University of California Riverside
Glen Mor 2 Student Apartments Project
Final Environmental Impact Report
Volume 1 of 4 Responses to Comments,
Draft EIR Text Changes, and Mitigation Monitoring Program

**UNIVERSITY OF CALIFORNIA, RIVERSIDE
GLEN MOR 2 STUDENT APARTMENTS PROJECT
FINAL ENVIRONMENTAL IMPACT REPORT**

April 2011

Modeled shadow patterns for June 21st at 6:24 PM. Sunset occurs at 8:04 PM.

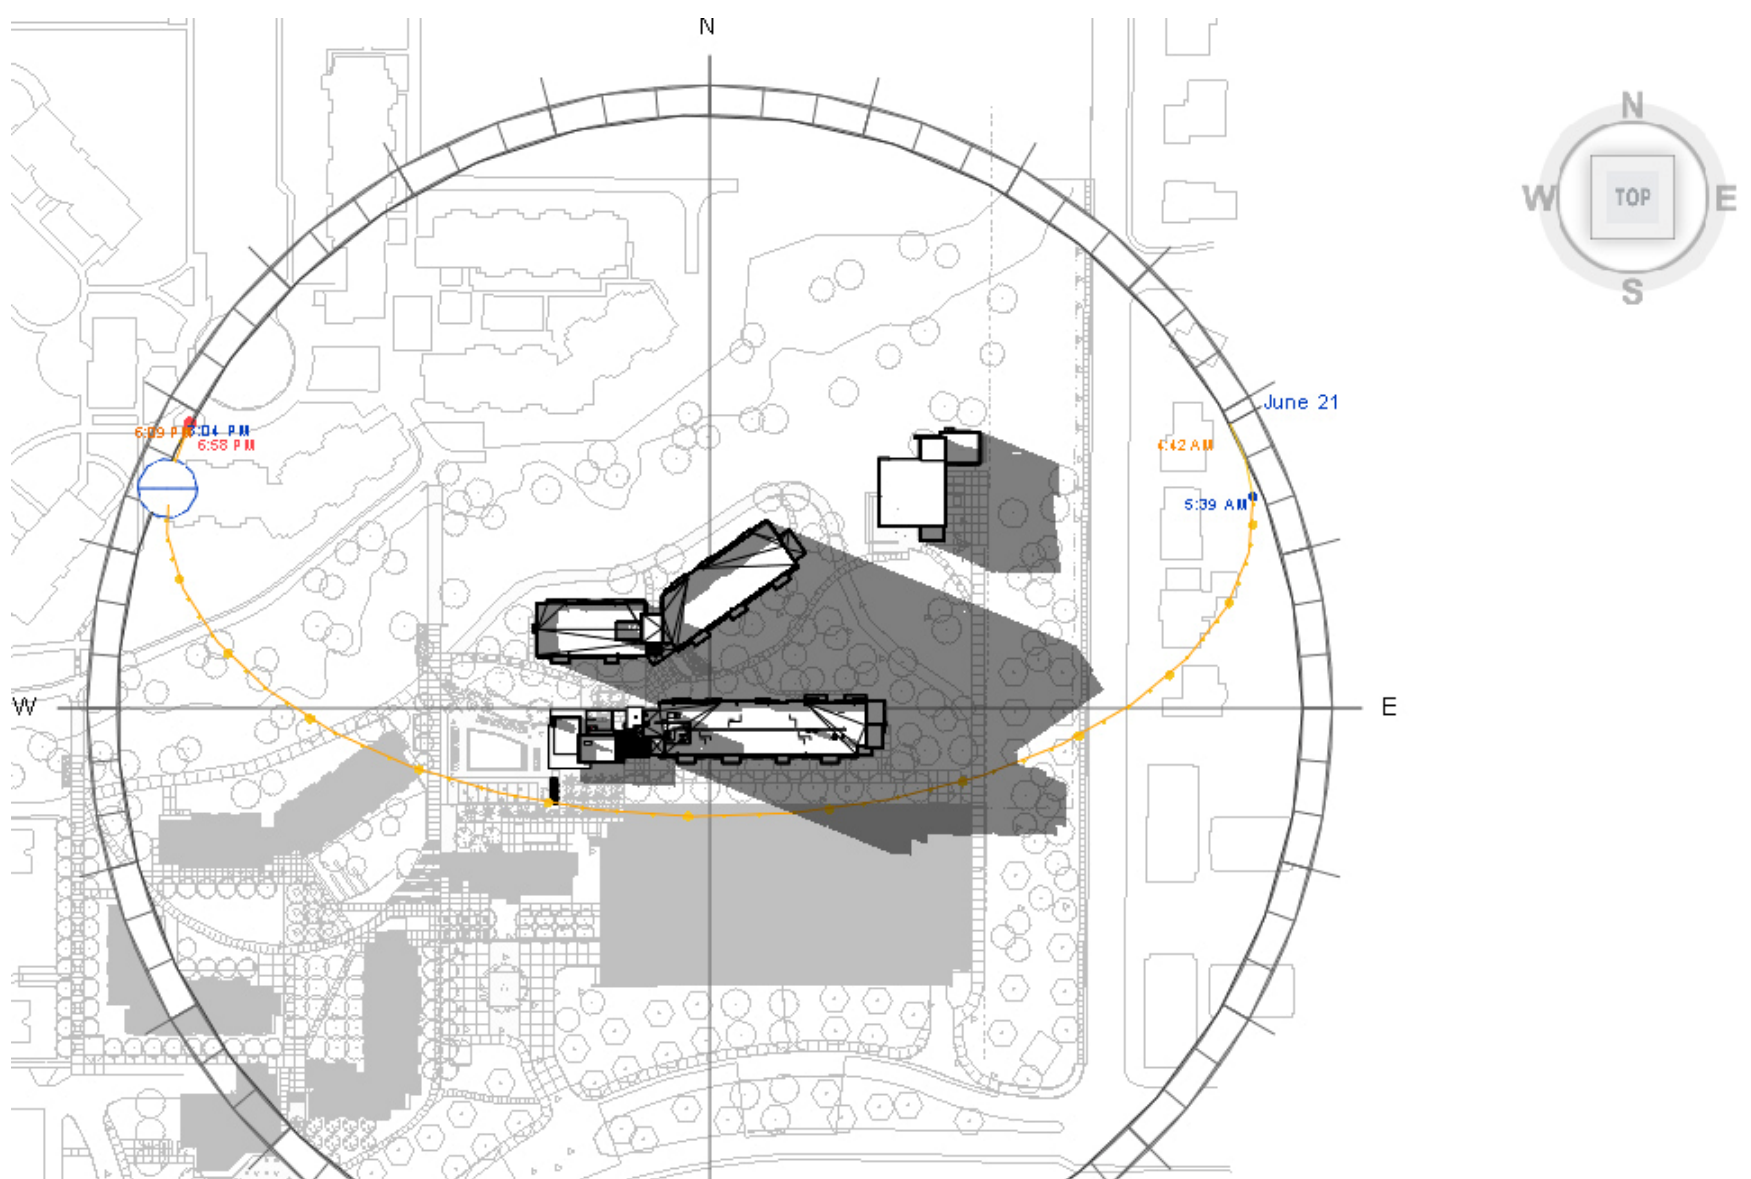
The planned dormitories may be significantly higher than the existing dormitories further inside the campus. It is unclear if and to what extent the foundations are planned to be sunken within the natural hill on the site or placed behind it.

The project architect has prepared a series of diagrams that depict shadow conditions created by the proposed buildings for the extreme circumstances associated with winter solstice and summer solstice. These diagrams have been added to the EIR as part of the Final EIR errata (Appendix B.1). The diagrams illustrate comparatively limited effects to shadowing of off-campus areas. Due to the relative position of the buildings and the movement of the sun, the area of concern is east of the campus, generally south of Goins Court. For the Winter solstice, shadows extend in a northeast direction and may be cast upon three single-family residential parcels east of Valencia Hill Drive for a period of less than 30 minutes immediately before sunset. For Summer solstice, shadows are cast in a southeast direction, and may be cast upon three single-family residential parcels and the University Village Apartments along Big Springs Road, east of Valencia Hill Drive. For summer, shadow effects on off-campus properties would be perceived for approximately 90 minutes prior to sunset. Furthermore, please note that most of the existing structures that would be affected by
